Access Compliance Report

Public Rights-of-Way (Curb Ramps)

Intersection ID: 9425	Main Street: GRIMES_ST	Cross Street: WINSTON_ST	Location: S
ADA ID: B502C56C4B3A	Ramp Type: Combination2	Initial Pass/Fail: Fail	Overall Compliance: No
		Severity Score: 67.5

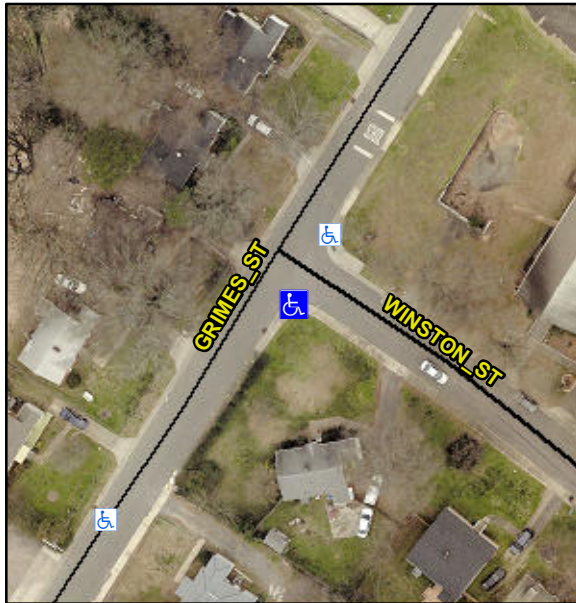
NO CURB LINE, LT RP < 5%

**R304.5.1, R304.2.2, R304.5.3,
R304.3.2**

Remove & Replace Entire Ramp.
